Town of Hilton Head Island
Design Review Board Meeting
Tuesday, November 10, 2020 – 1:15 p.m.
AGENDA

DESIGN TEAM/DRB COMMENT SHEET

PROJECT NAME: 28 Shelter Cove Lane

DESIGN TEAM/DRB COMMENT SHEET

**Repainting Siding Boards and Replacing Awnings Only at Existing New York City Pizza
All Tan Siding to be Universal Khaki
All Awnings to be Black**

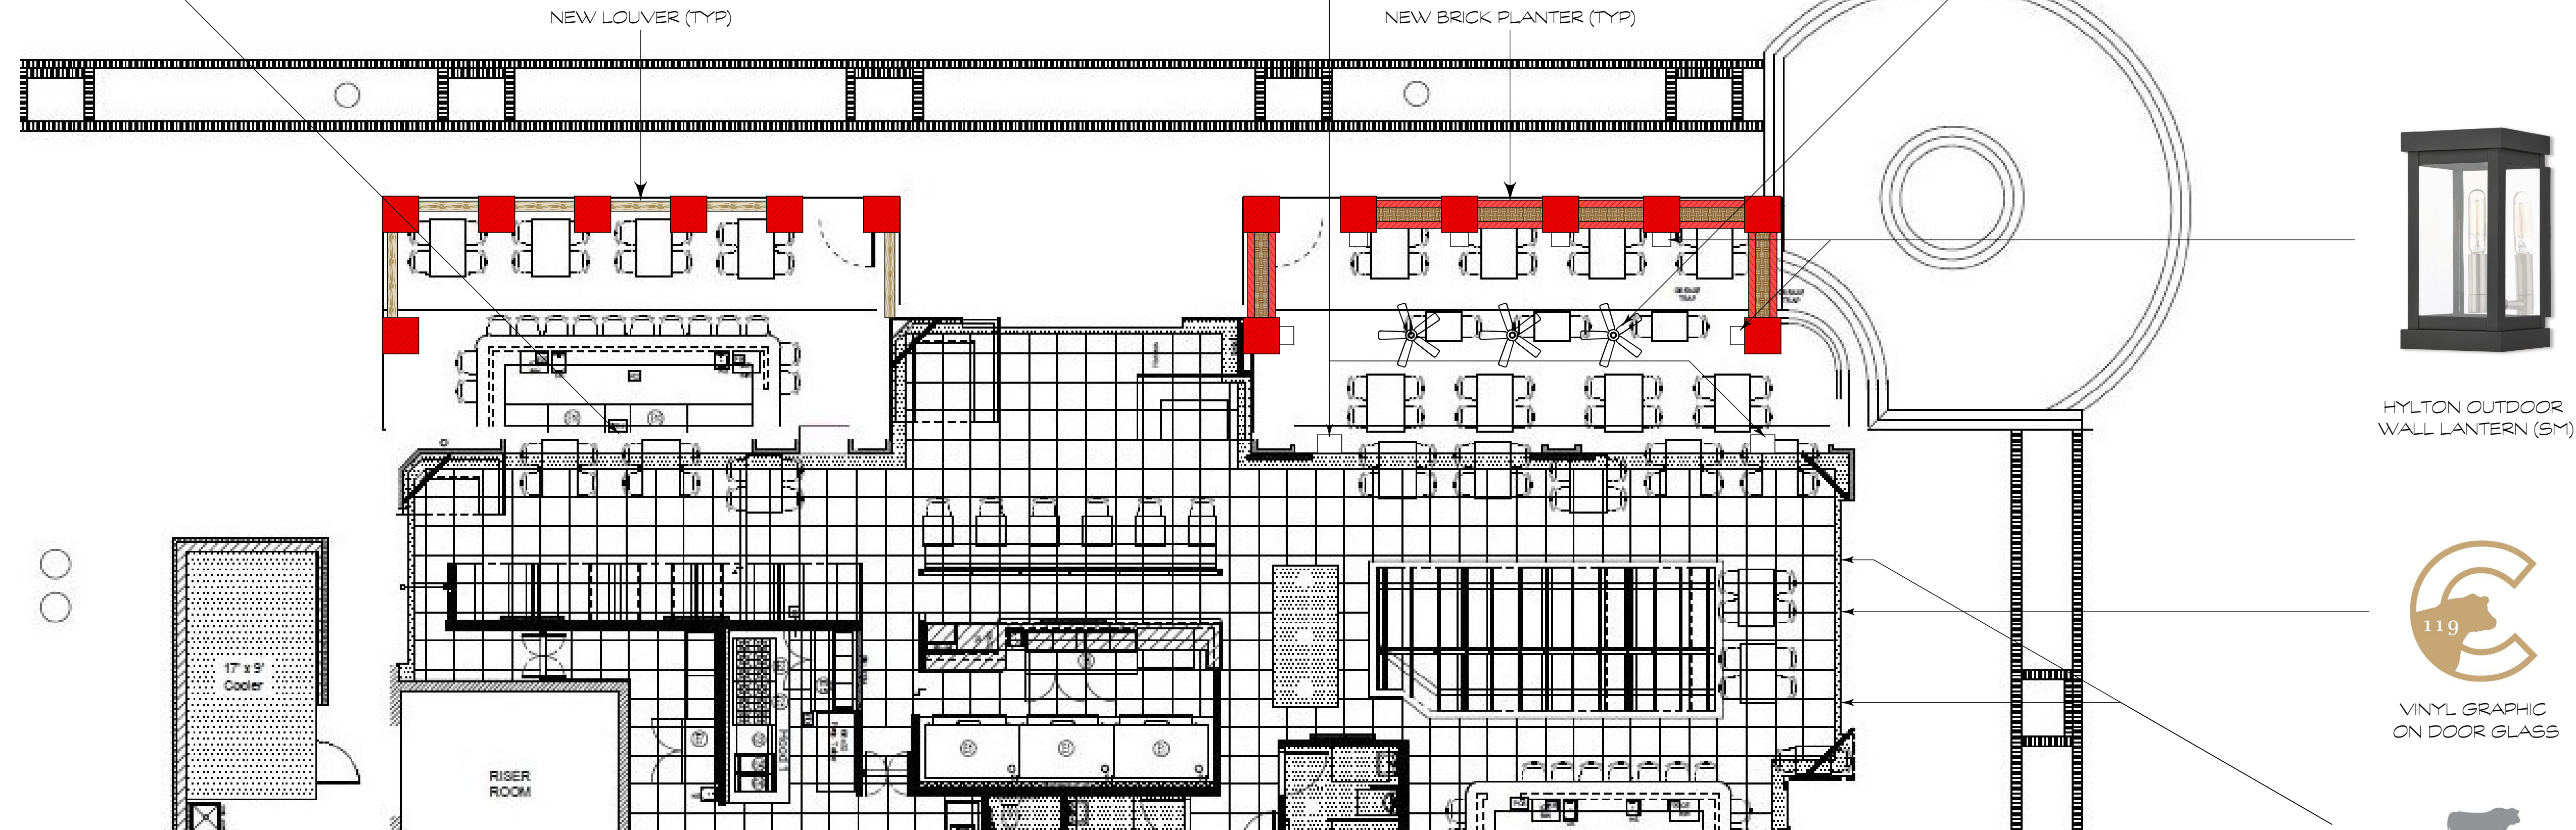
5. (narrative item 4) Staff suggest approval of the proposed exterior color change. The corner boards should be painted to match the trim color.
6. (narrative item 5) Staff recommends approval of the proposed awning color change.

DRB SUBMITTAL
A-001
KEY PLAN

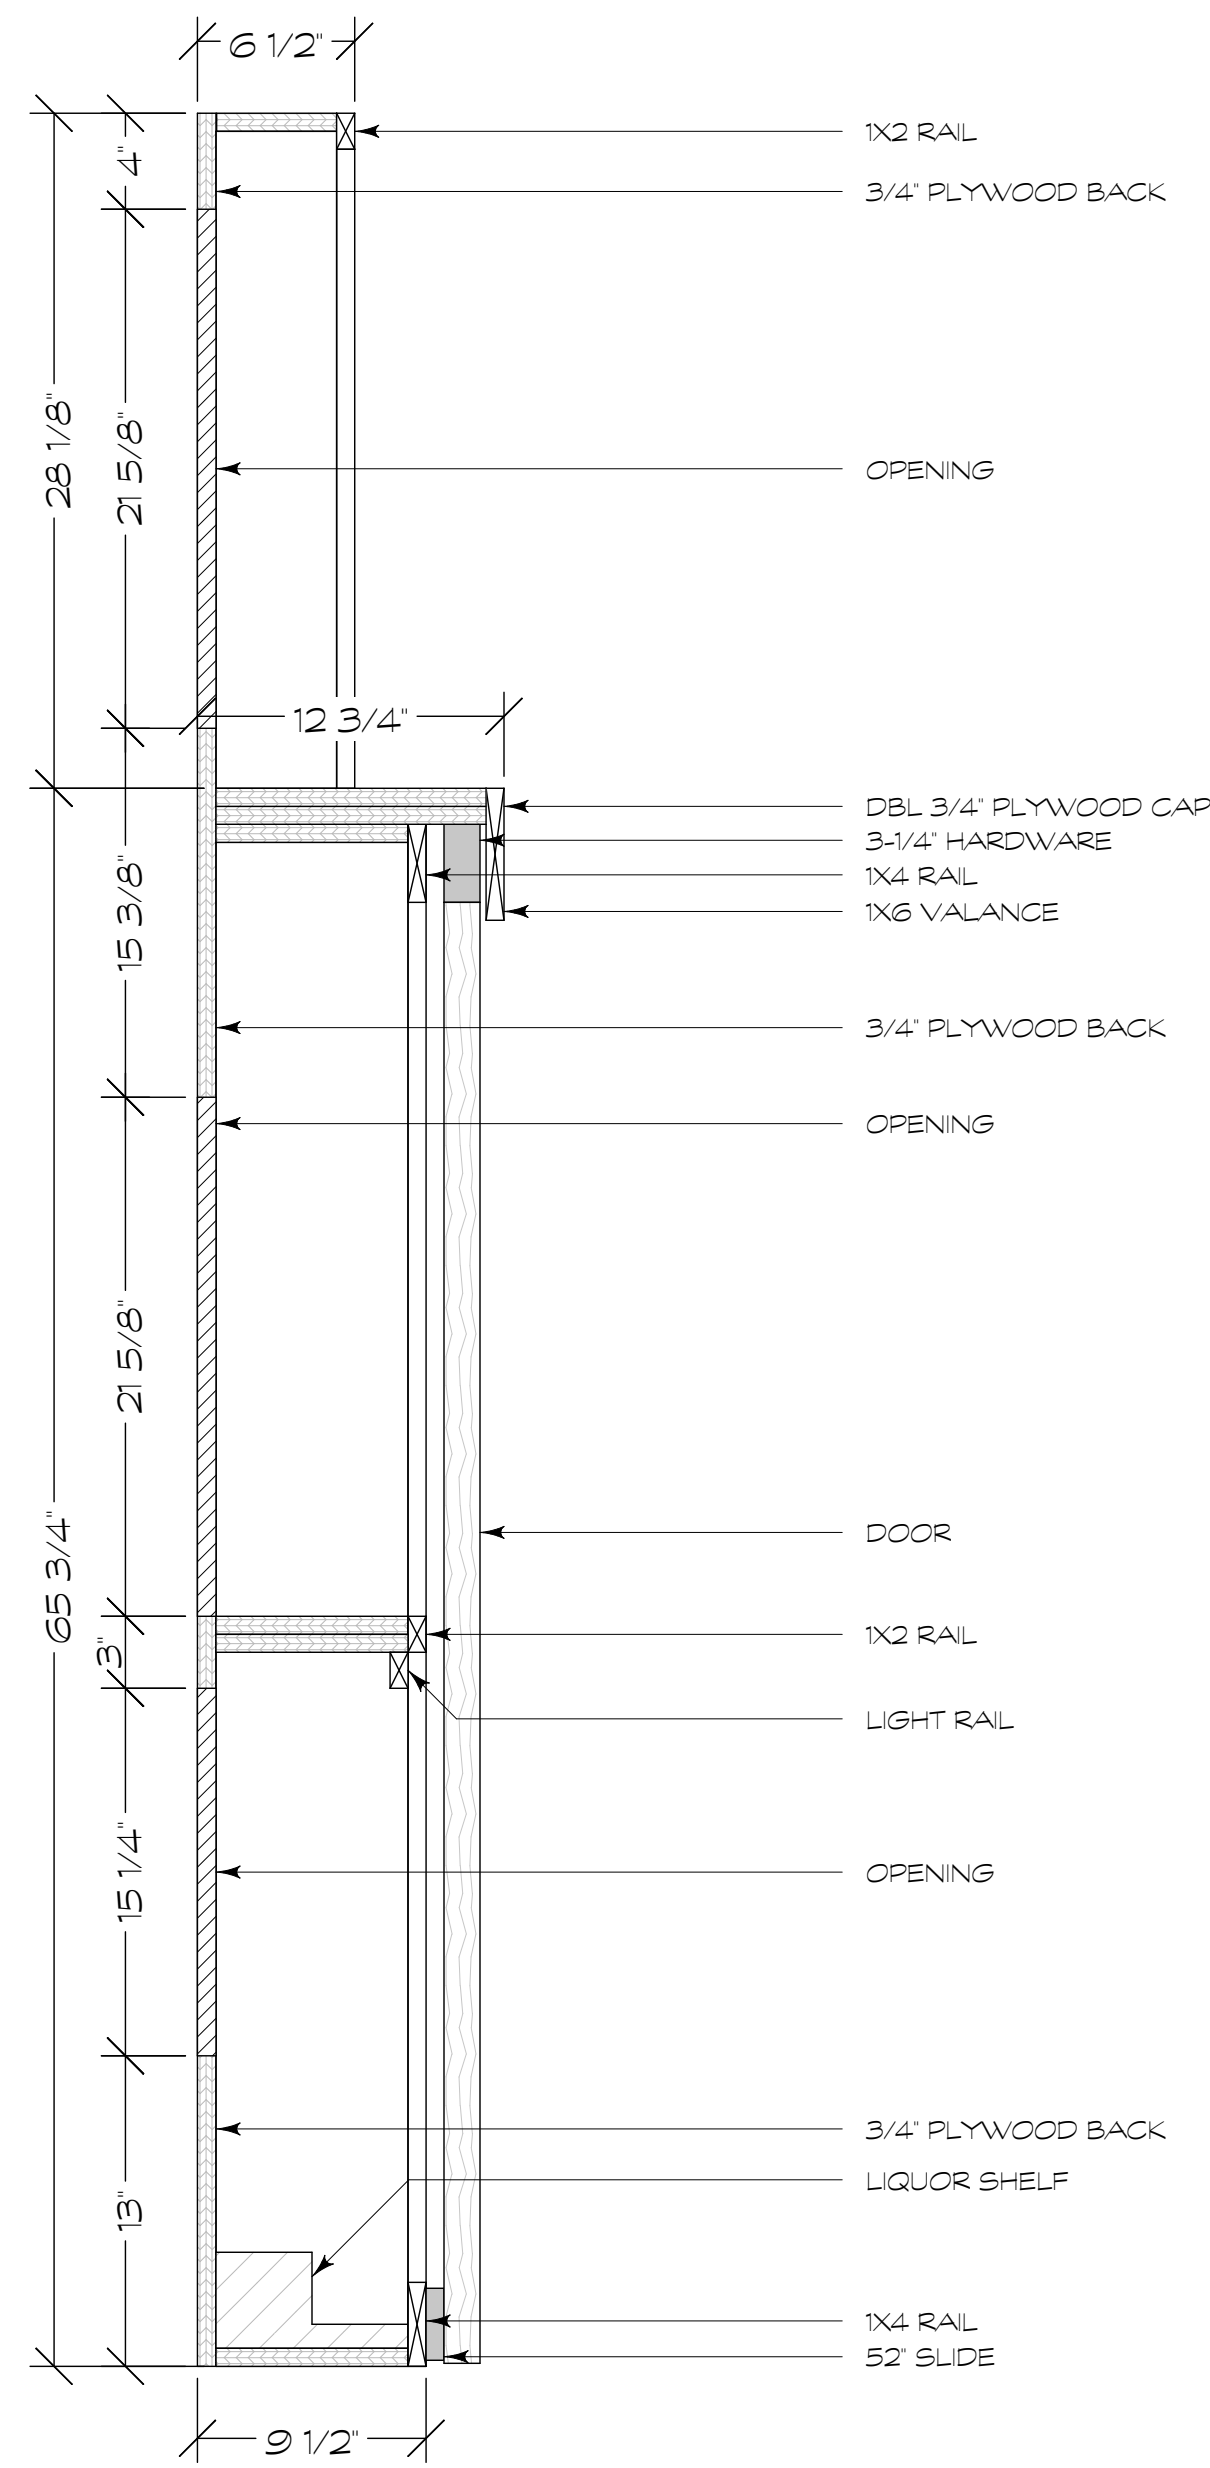
7. (narrative item 6) If the current sign is not going to be replaced in its location, the height / slope of the awning should be reconsidered to mitigate that

void.

8. (narrative item 7) Staff recommends approval of the fans and light fixtures provided:

1. the light fixture will not exceed color temp and brightness allowed.
2. a note is added to the plan that no conduit will be visible on the columns to the light fixtures.
